TECHNICAL INSTRUCTION

TI 133

NETWORK RAIL - SIGNAL ENGINEERING

New Design of Toe and Supplementary Rail Position Sensors (LVDTs)

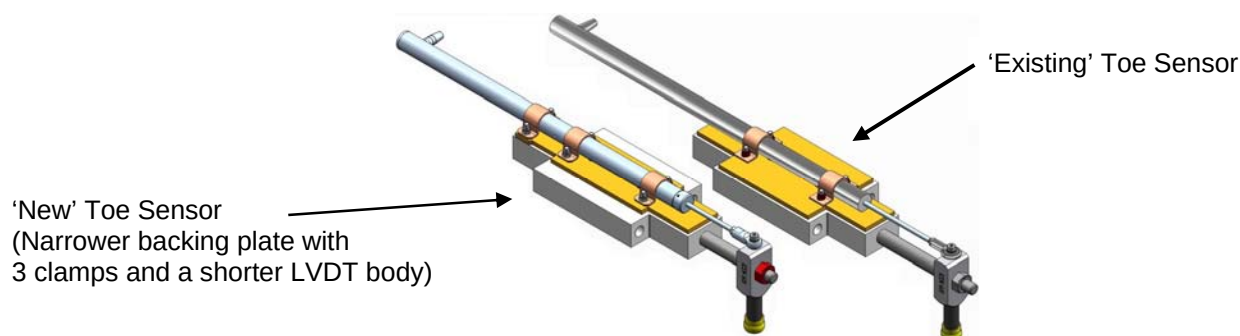
The following illustrations provide detail of the new Sensor design and difference between the superseded 3mm Supplementary bracket and the preferred 5mm design.

Note: The only design change to Supplementary Sensors is use of the new (shorter) LVDT.

The Supplementary Sensor Mounting Bracket should be the 5mm thick design which is secured using 4 M12 screws. Some layouts are fitted with a 3mm thick, 2 bolt bracket design, which is now superseded. If Supplementary Sensors are being replaced and the system is fitted with the superseded 3mm design, these shall be replaced with the 5mm thick design. Information on how to order the brackets is provided later in a table along with new Sensor details.
